SERVICE BULLETIN

Title: Oil Radiator Fitment XT 912

Identification	SB-023
Status	Advisory
Issue	1
Issue Date	15 September 2020
Applicability	All XT 912
Compliance	When replacing Oil Radiator

Oil Radiator Part Numbers

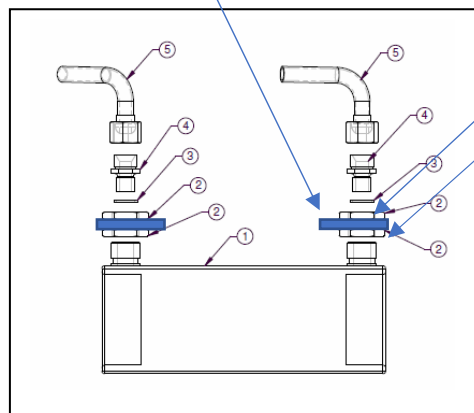
The threaded flange on the new version Oil Radiator is shorter than the previous model and the flange has a different set where it is fixed to the radiator body.

The standard Oil Cooler fitment on Airborne XT-912 is the 125 sqcm variant. Larger radiators require a Letter of Approval for fitment from Airborne.

Assembly Detail

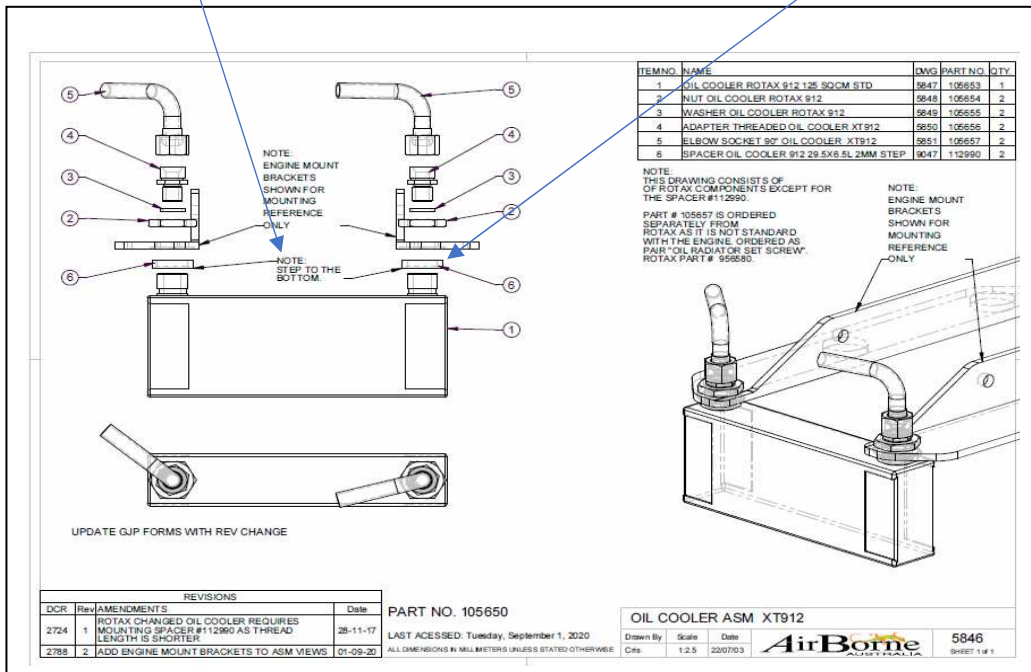
Older model radiators had two oil cooler nuts (Item 2 - Airborne Part # 105654) positioned either side of the attachment point of the engine mount.

2017 versions and after require Spacer (Item 6 - Airborne Part #112990) and only one nut.
 Note orientation of spacer

The new version radiator must have spacer (Airborne part #112990) fitted between the radiator and the engine mount. Failure to do so will put undue stress on the radiator causing failure at the flange attachment point.
